Proposal for amendments to UN Regulation No. 13

Proposal for a Supplement to the 11, 12 and the 13 series of amendment to UN Regulation
No.13 (Heavy vehicle braking)

New options/alternatives to classic Type-IIA for ERB

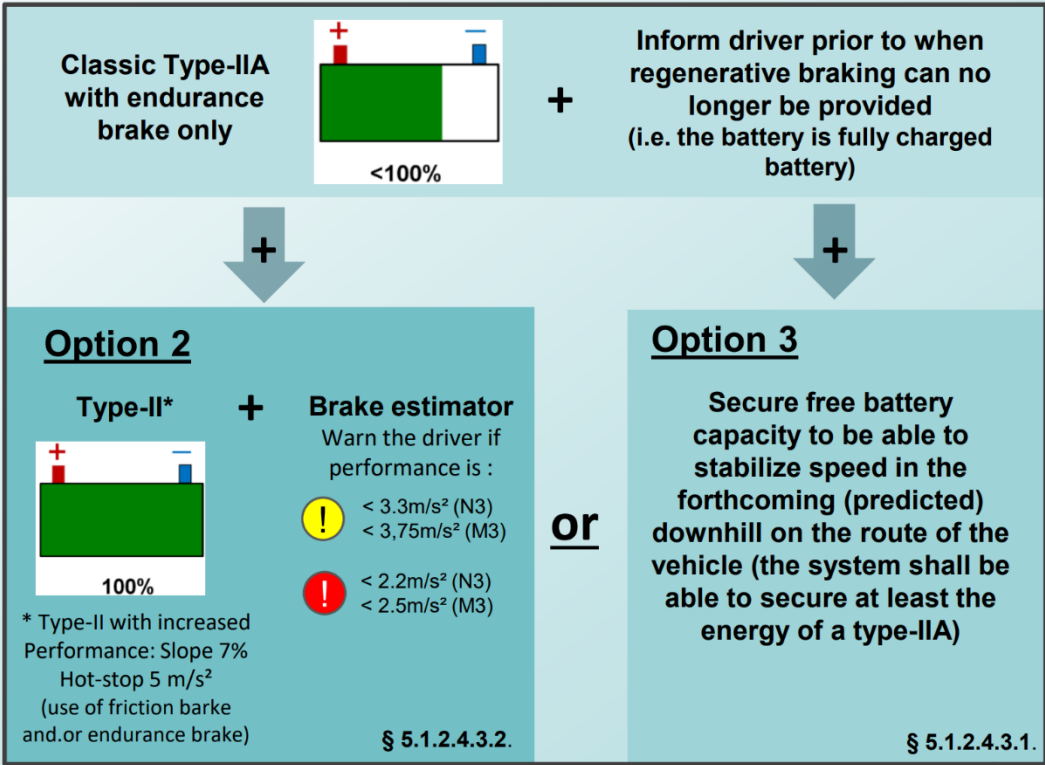
- In reviewing the adopted provisions, the UK does not consider that it is abundantly clear that the Type IIA test should always be performed at least in the case where the battery is in a state of charge that it is expected absorb the energy from the decent of the vehicle.
- The proposal is a clarification to make the current understanding more precise. It is also noted that the drafting around these provisions is not ideal and that more work is needed to ensure that the requirements are understandable and not open to misinterpretation.
